Coal Free Southern Highlands Inc.

Discussions with the Independent Planning Commission

Hume Coal Project – 2nd Referral
June 29th, 2021

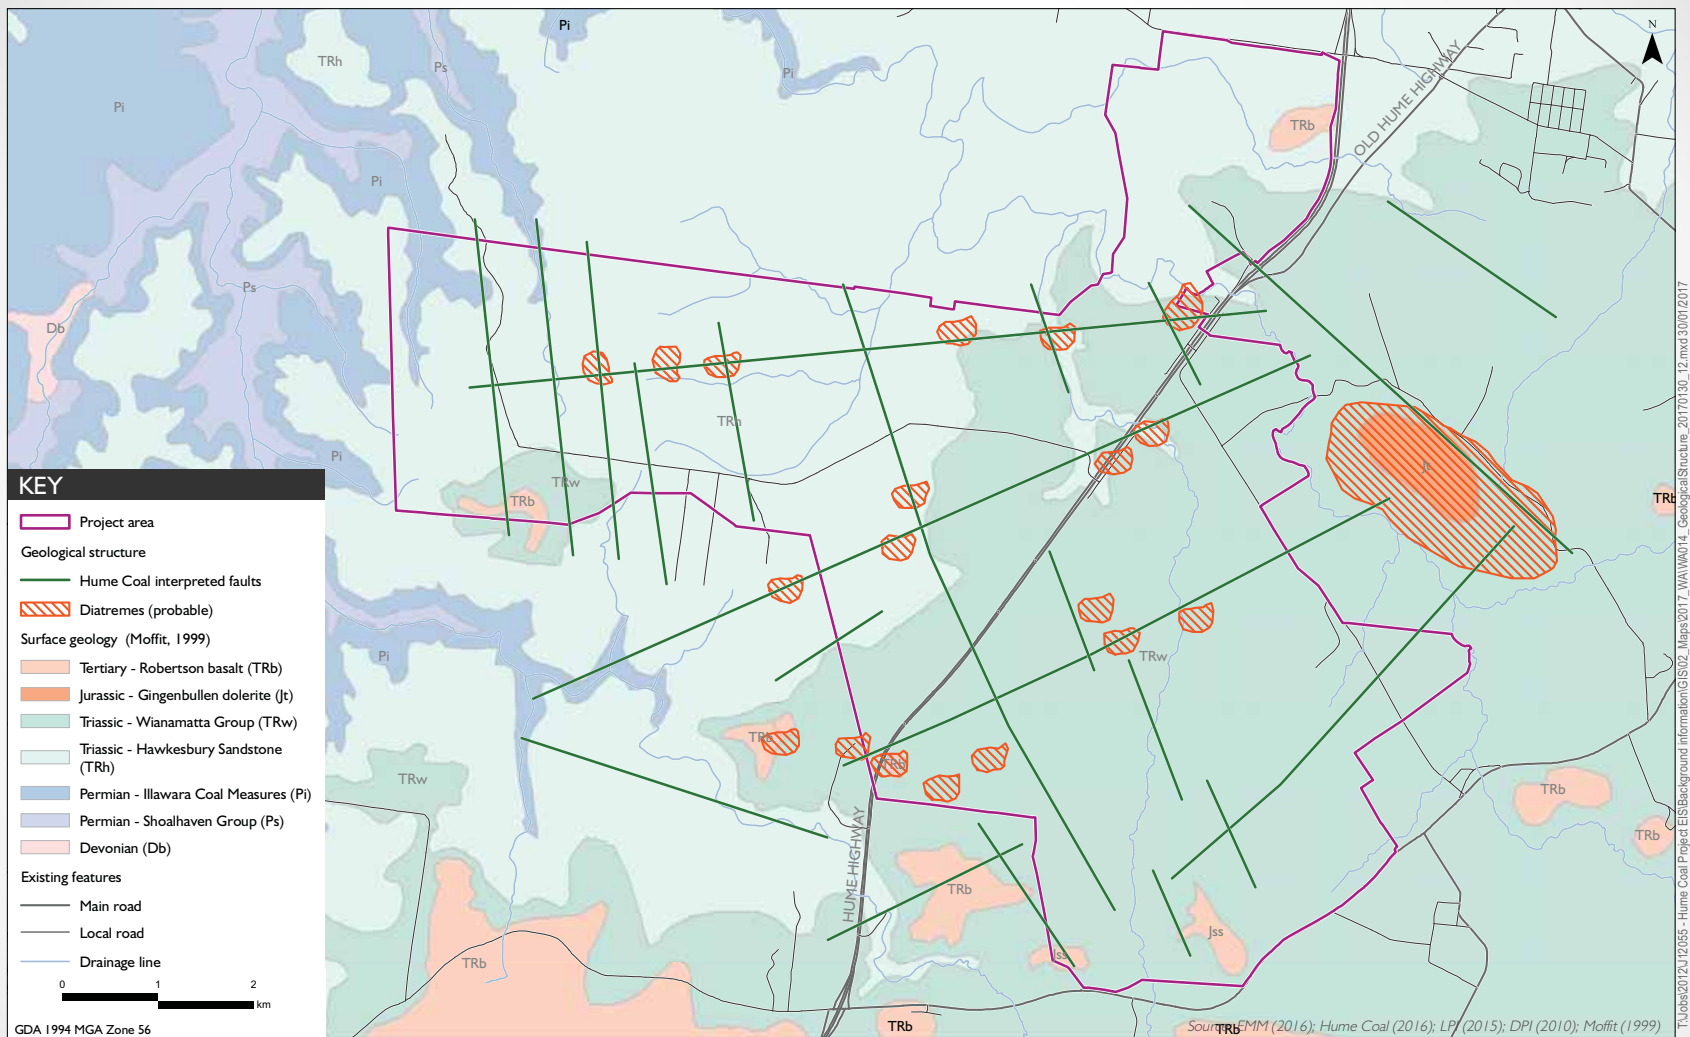
Hume's proposal March 2014 REF 3

150 drillhole locations nominated
90 to be selected
100 metre radius of flexibility

DRE rejected this proposal
July 2014 – 25 holes approved

Just 3 holes were eventually
drilled, all west of the highway

Figure 6.5

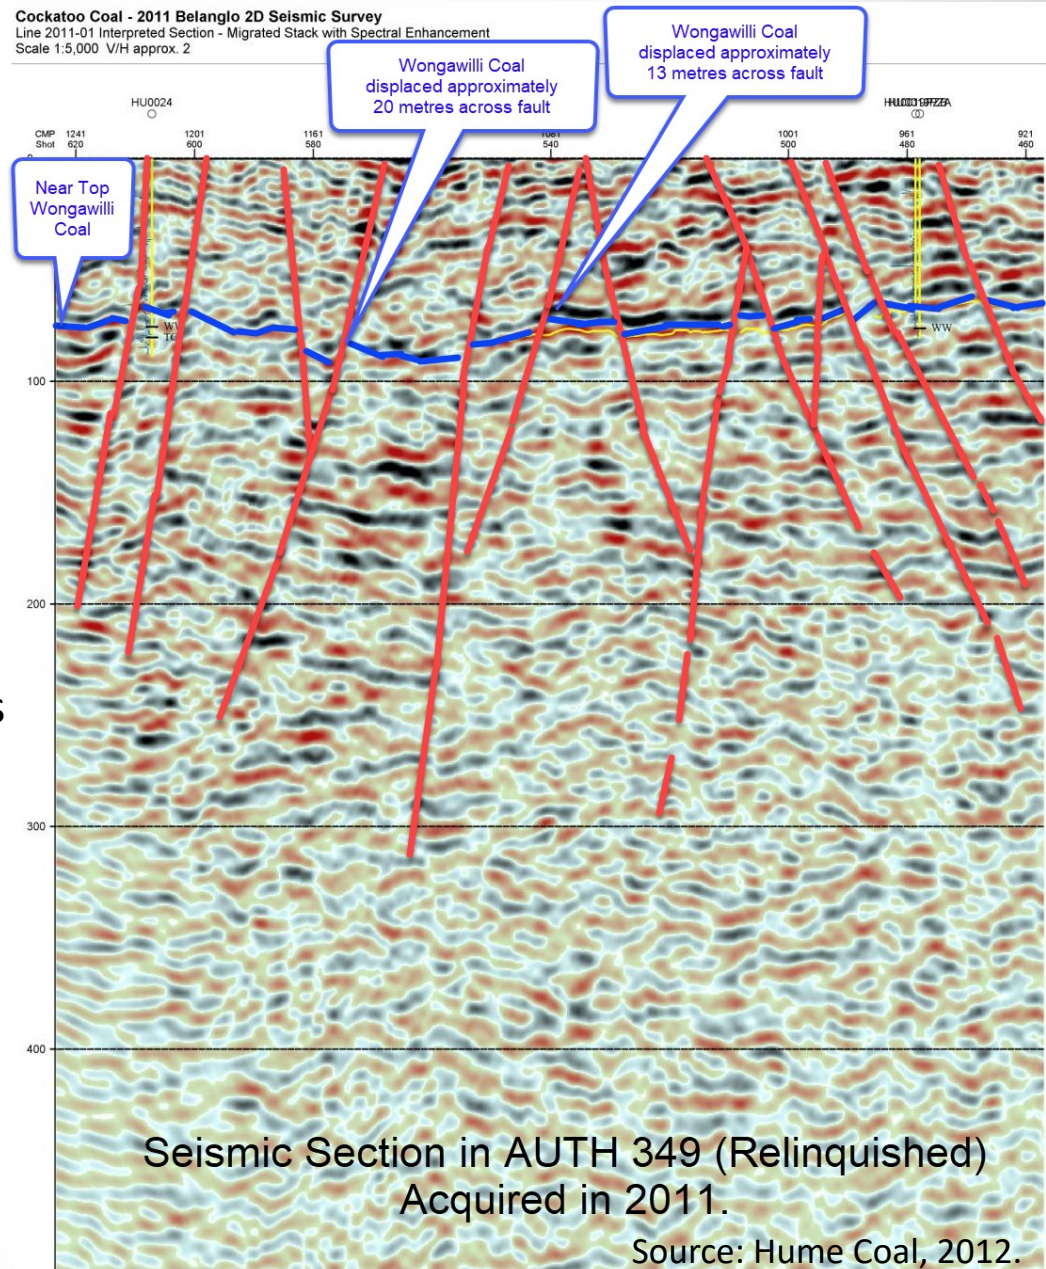
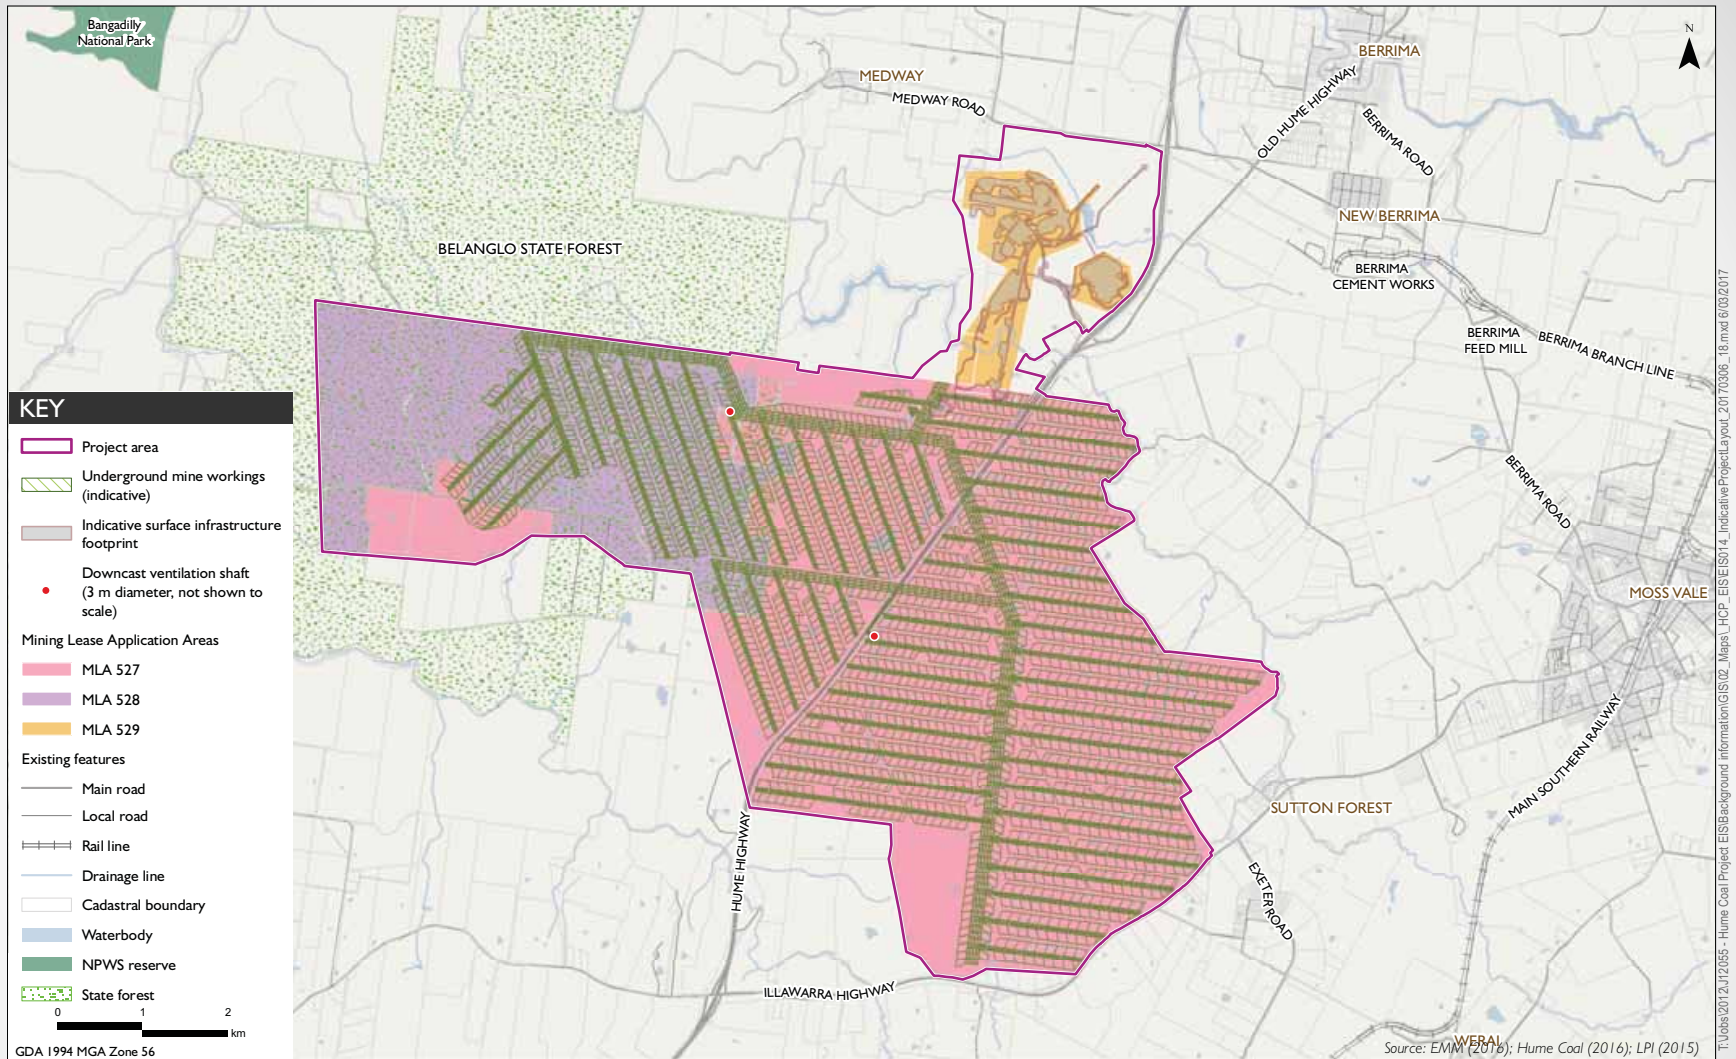
- Seismic Data demonstrates that:
 - faulting places the Hawkesbury Sandstone horizontally against the Wongawilli Coal
 - The structure of the top of the Wongawilli coal does not "...dip gently from west to east...at...a grade of 1 in 100"(Fitzsimmons & Doyle, 2017). Rather, it is faulted and is involved in both anticlinal and synclinal features
 - The Wongawilli Coal is highly fragmented into separate and non-contiguous bodies across faults.

- Geological structure within AUTH 349 is much more complex than the Operator has portrayed in the proposals.

Figure 5 | Make Good Strategy Flowchart (Source – Hume Coal Response Report)

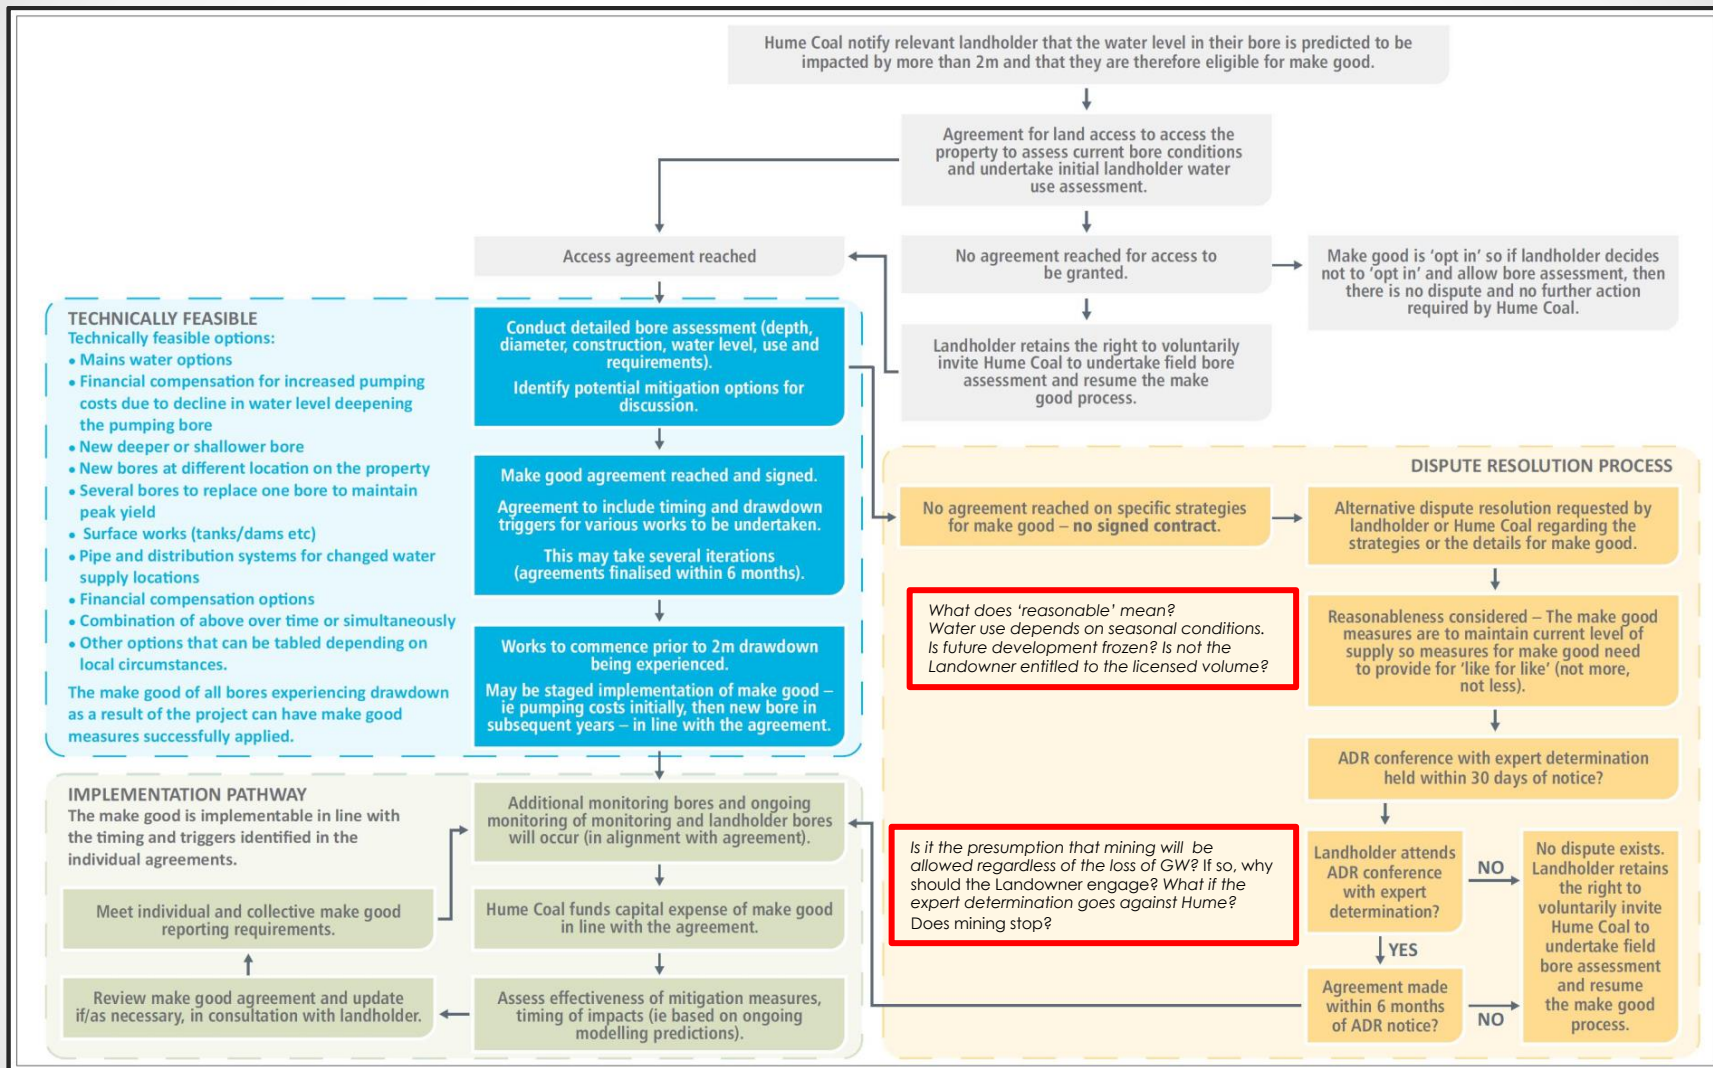
Hume's strategy to force landowners to be part of their make-good process is revealed in appendix K(1) of the IPC response. It has 2 parts:

- Hume wants procedures similar to that for land access for exploration that compel landowners to 'opt in' to their make-good plans. Landowners would be required to enter into legally binding agreements prior to mining impacts occurring or face a punitive arbitration process.
- In situations where make-good cannot be achieved, Hume want a process akin to the VLAMP provisions for noise mitigation. The DPIE Secretary would set the level of landowner compensation for loss of water. However, there are serious flaws with the VLAMP approach.
- *Land access for exploration and VLAMP for noise are legislated but Hume want the Govt to use specially designed conditions of consent in lieu.*
- *DPIE consider this approach unworkable. Conditions of Consent capable of dealing with Hume's risks and uncertainties cannot be developed*

Figure 11 | Project drawdown and proposed 'make good' provisions

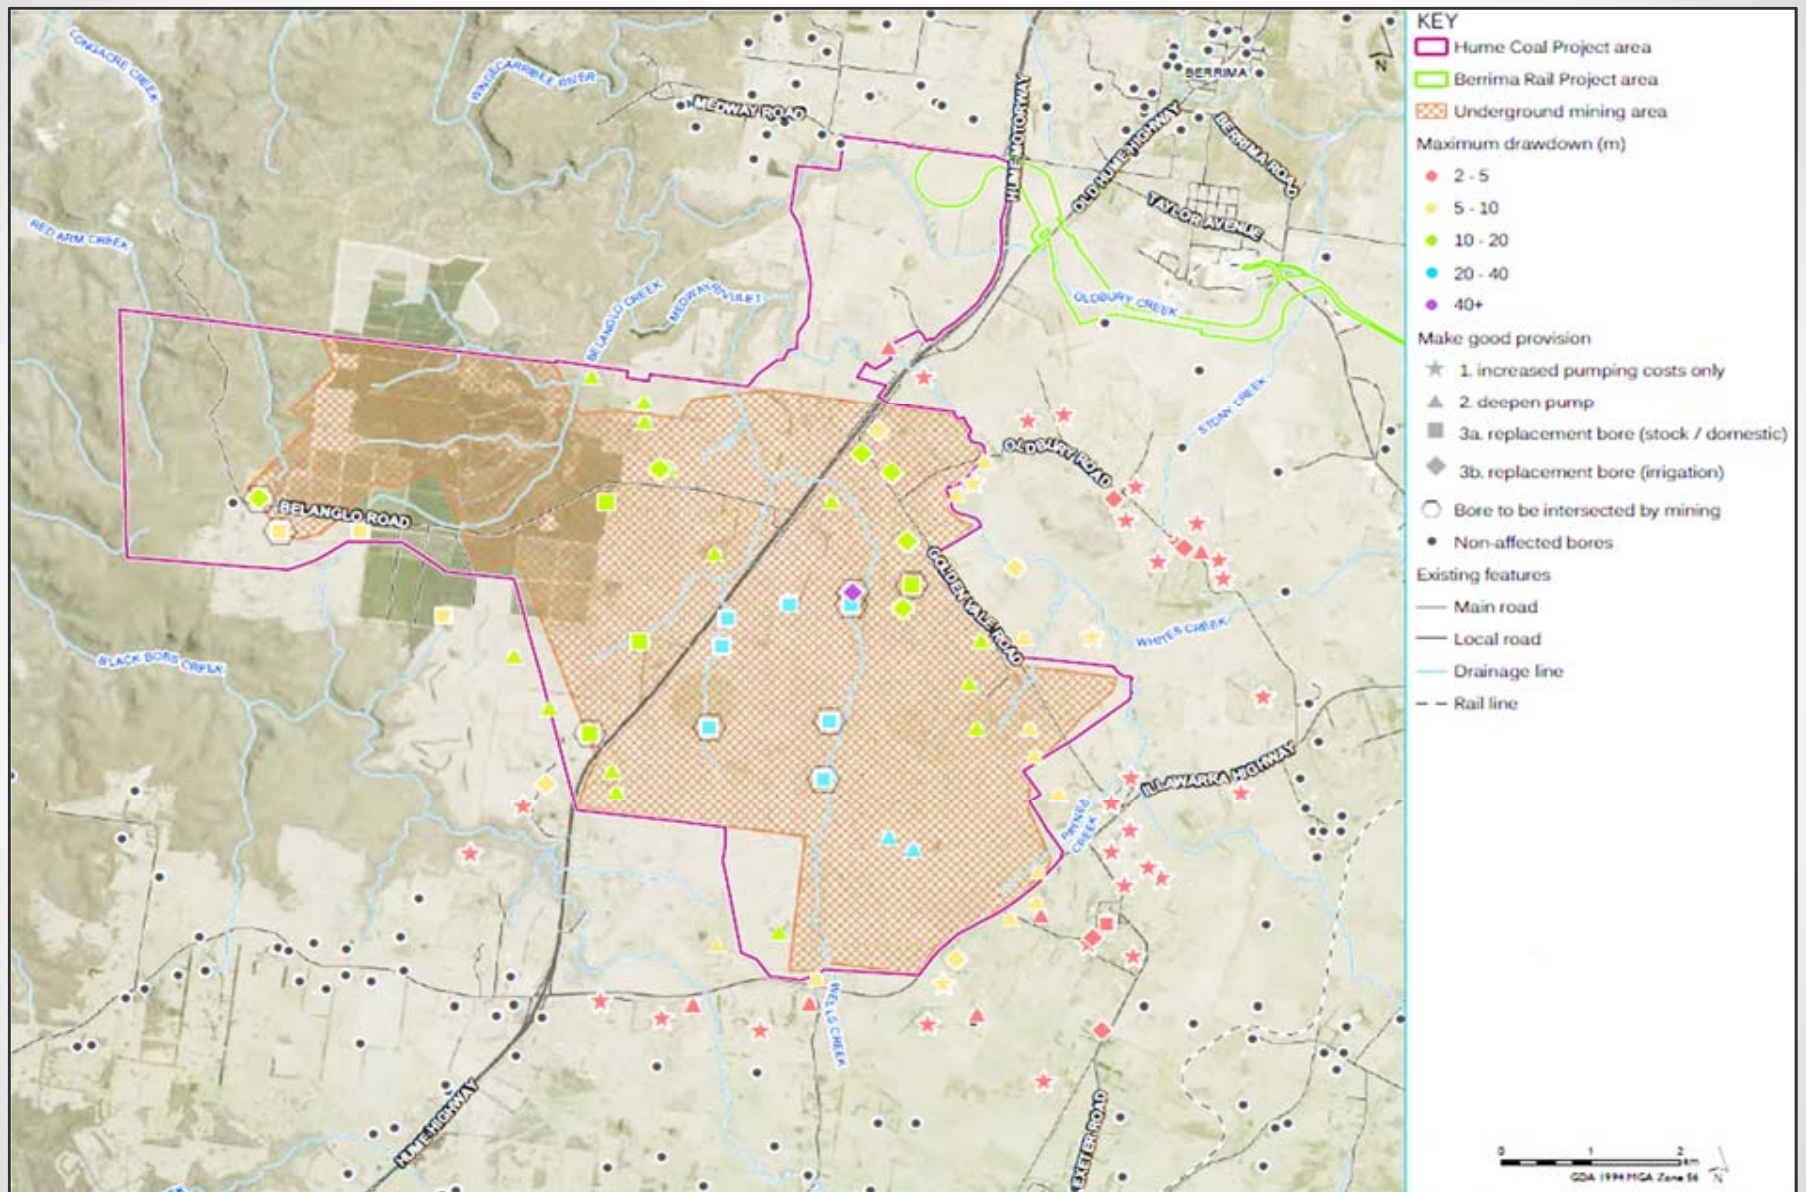
- Groundwater and surface water
- The Hume mine faces serious groundwater challenges. The number of affected bores far exceeded prior NSW experience, and with some of these bores the make-good GW volumes cannot be achieved.

- The proposals put forward to resolve GW disputes are unacceptable to the DPIE and CFSH. They would amount, in some cases, to a government mandated acquisition of legally held landowner water licenses .
